15005/LTR/0005/AC

Aldi, Bridge Street, Brigg
Discharge of Conditions for PA/2016/995

Subject: Discharge of Conditions for PA/2016/995

Location: Aldi Stores Ltd Bridge Street Brigg

Title
Proposed Drainage Layout

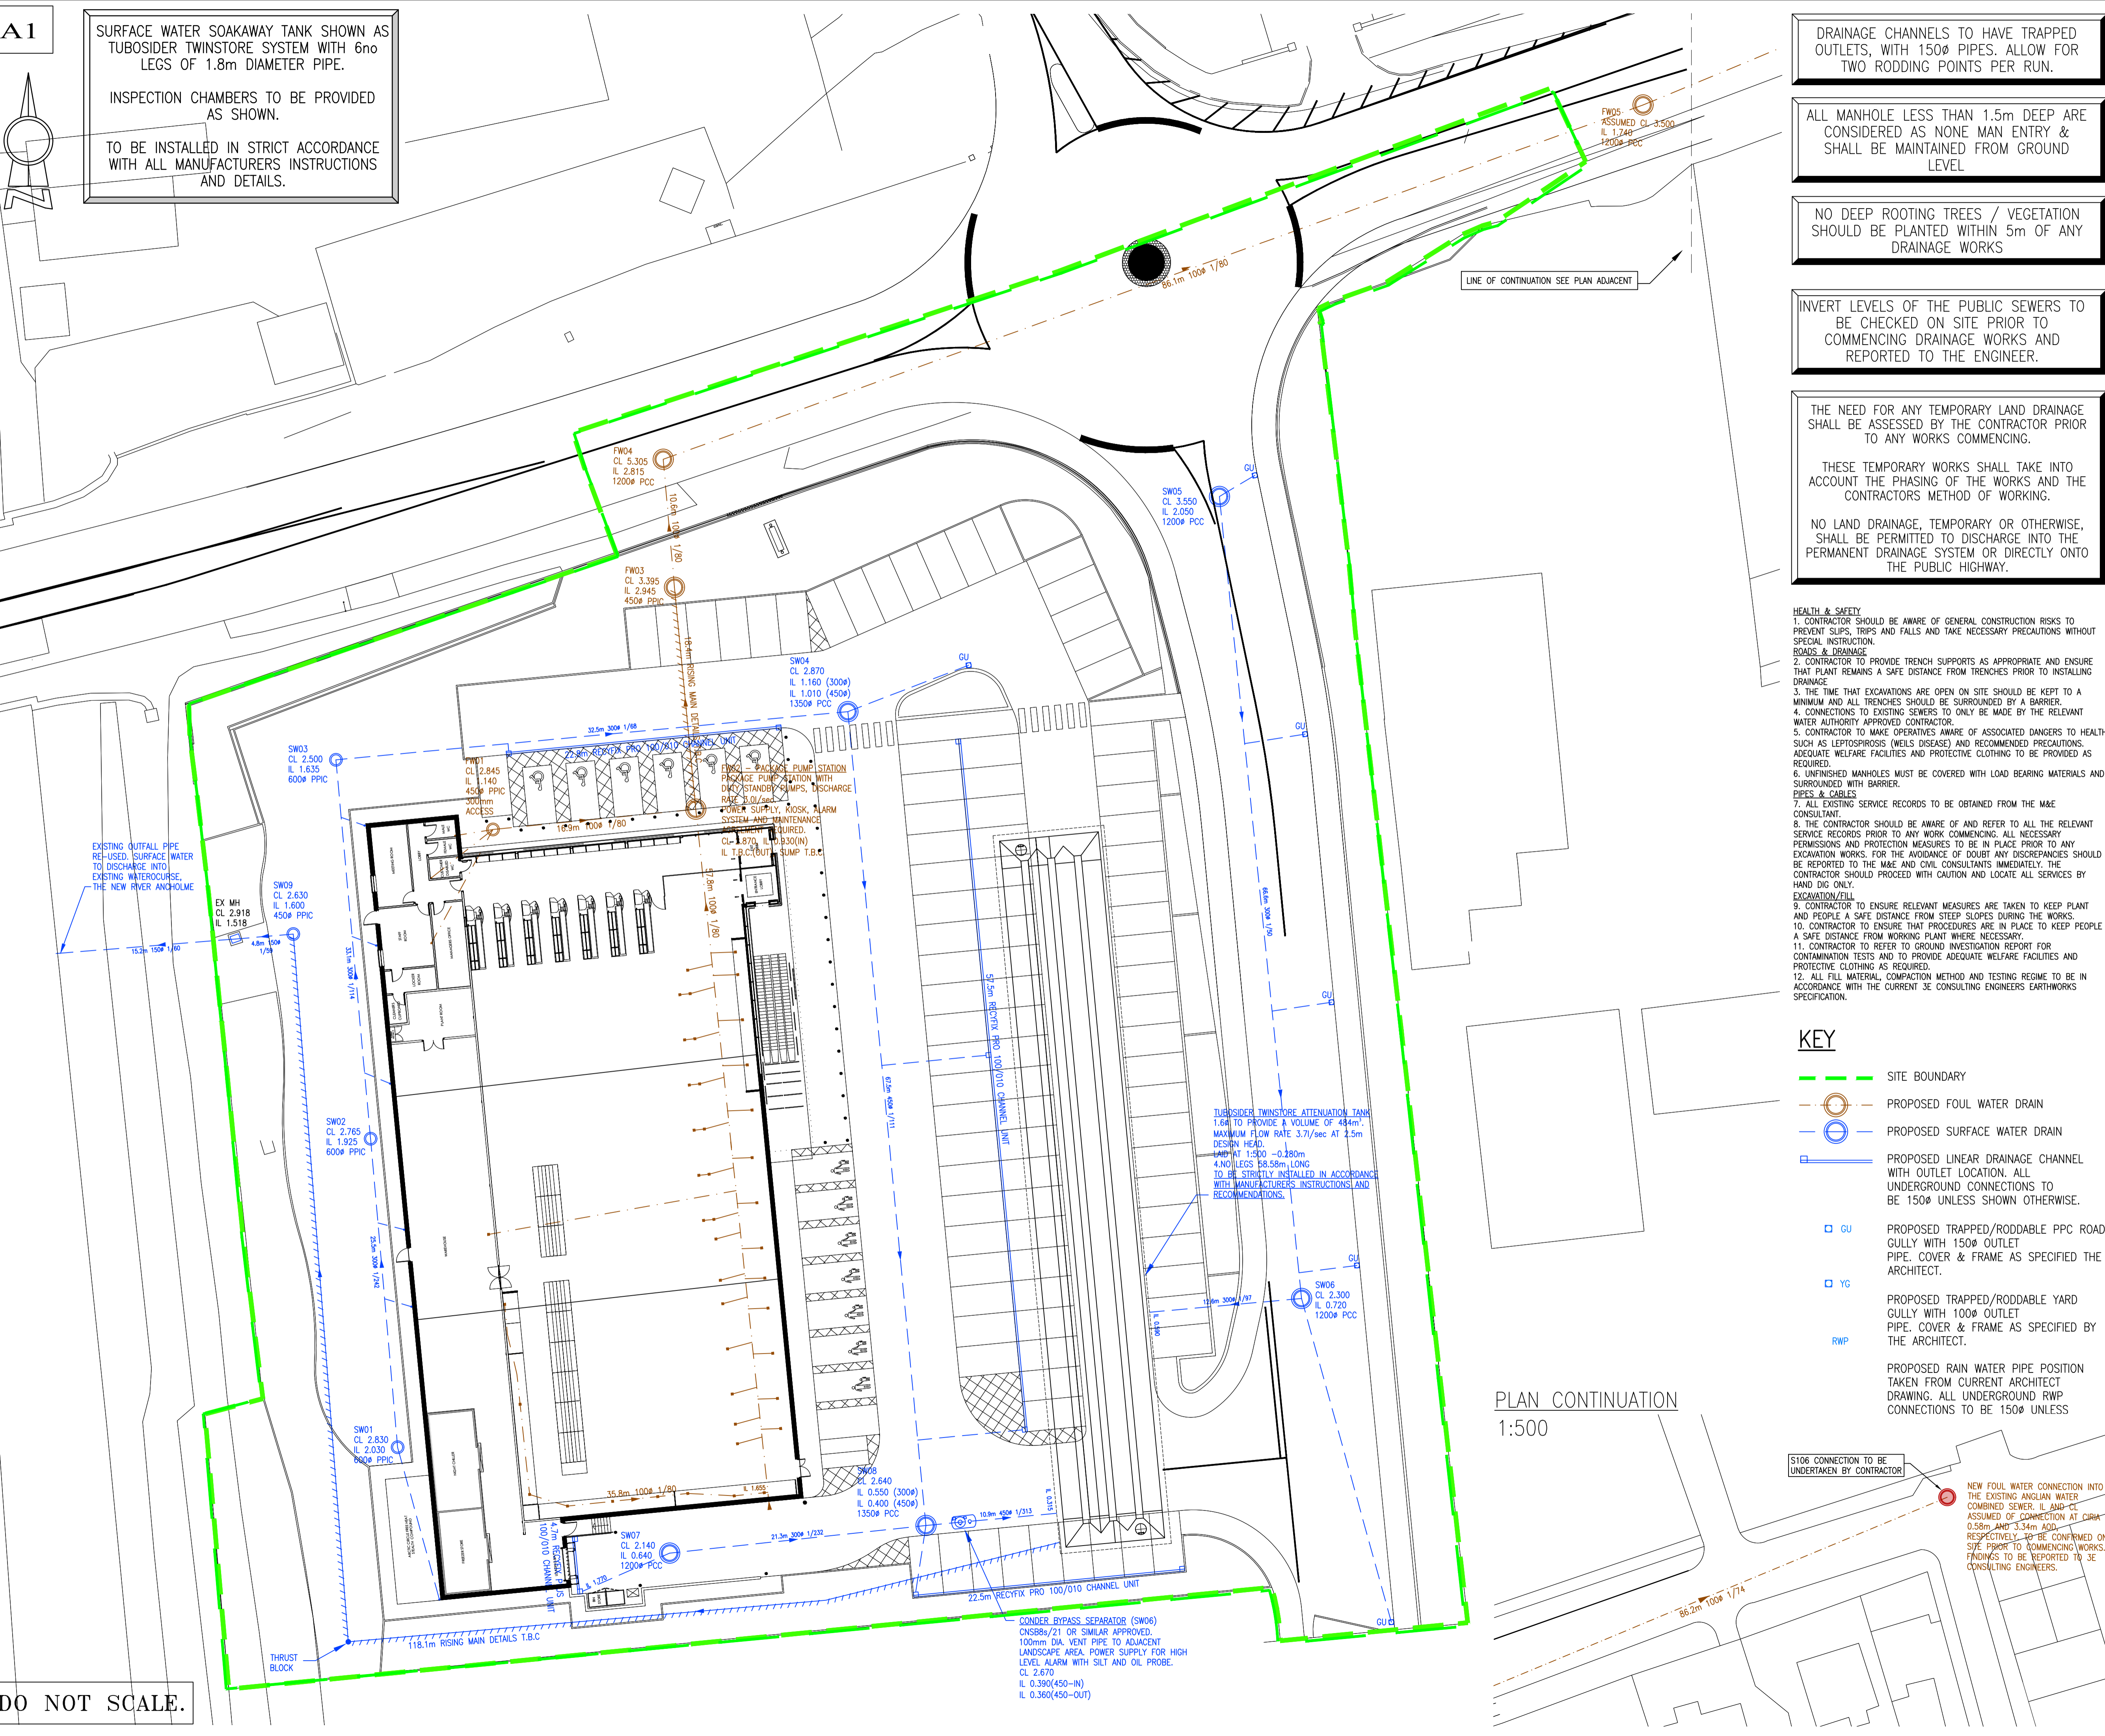
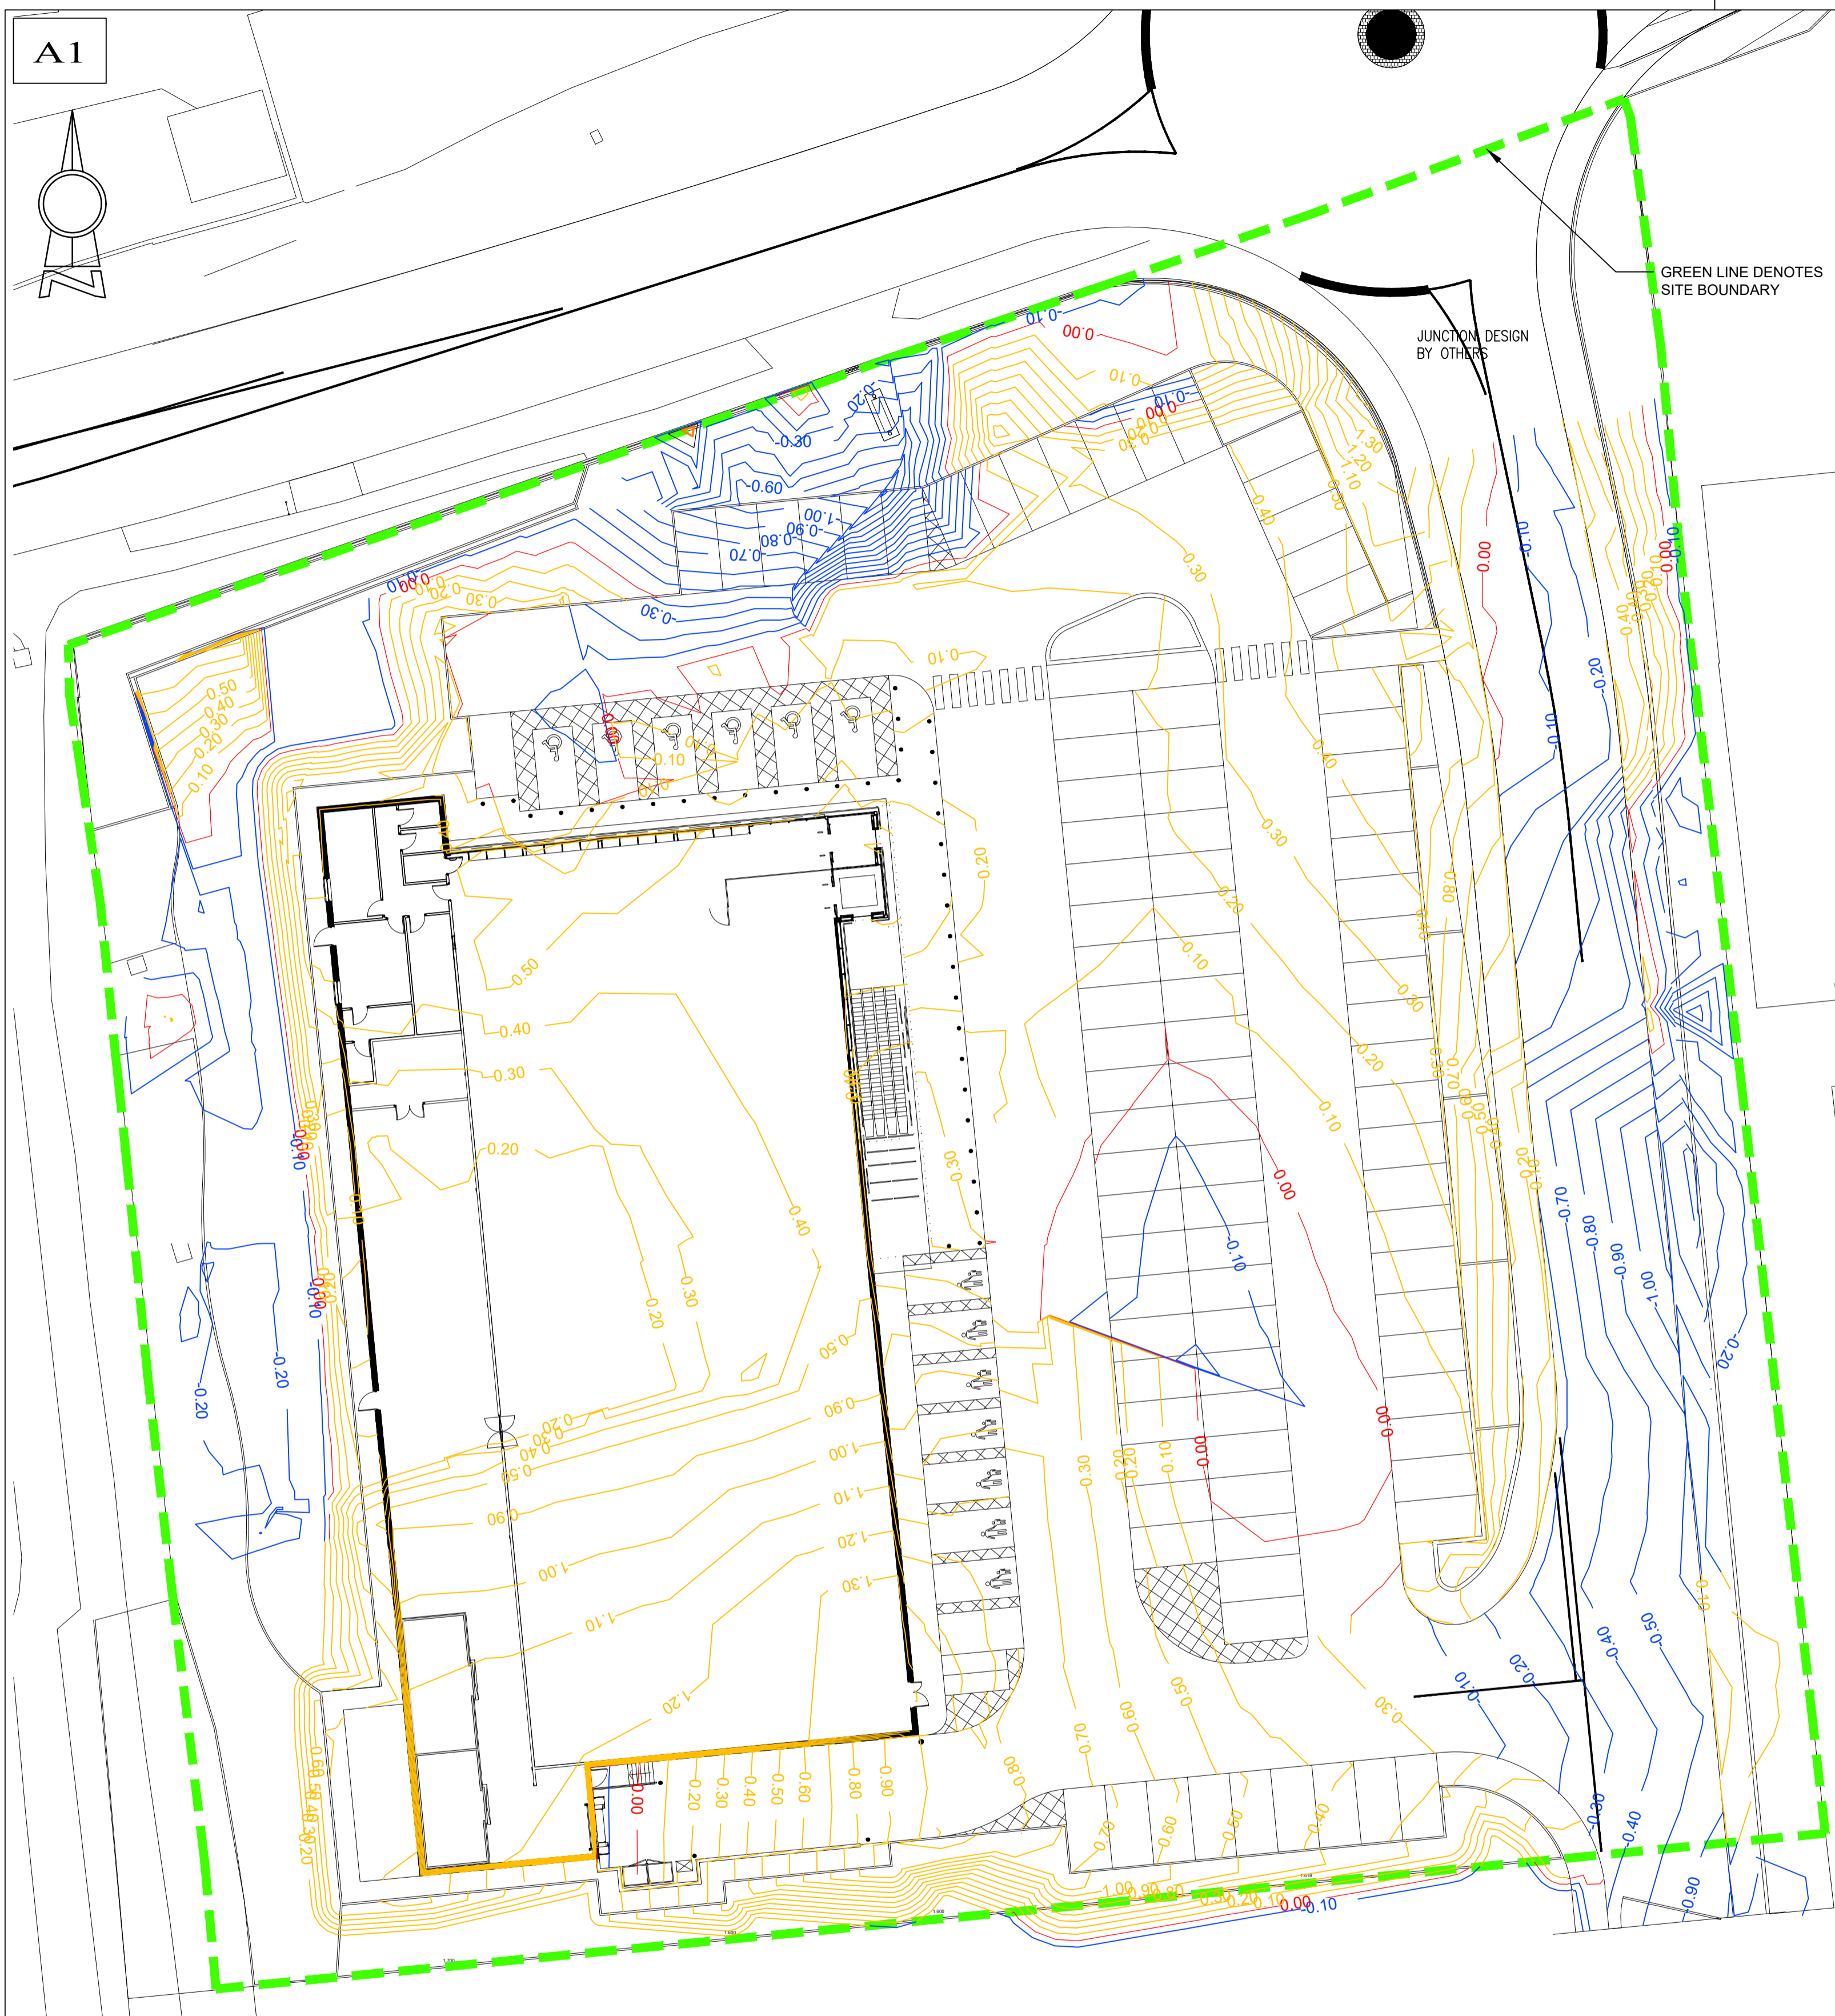
7. The assessment of asbestos risks associated with the movement of made ground has not yet taken place as part of the remedial scheme.
8. The design of surface water disposal taking into account the fact that a soakaway has been identified as unsuitable for the site has yet to be designed and submitted for approval.

- 4 The cover system installation and validation is set out in Section 10.20 onward in the DQRA and Remediation Statement, which is based on YALPAG guidance.
- 5 During the remediation works surface water will be controlled by the specialist contractor, details of which they will provide under separate cover. In the permanent situation it is proposed that surface water will be formally drained via an attenuation tank (and oil separator for the car park), prior to discharge to the adjacent watercourse, as per the hierarchy for surface water disposed set out Building Regs and drainage authority requirements, drawing attached for detail.
- 6 To be addressed others, but it should be noted that it is intended to raised levels on site across the majority of the site, therefore, services runs will generally lie within imported fill, see attached Earthworks Analysis Drawing for information.
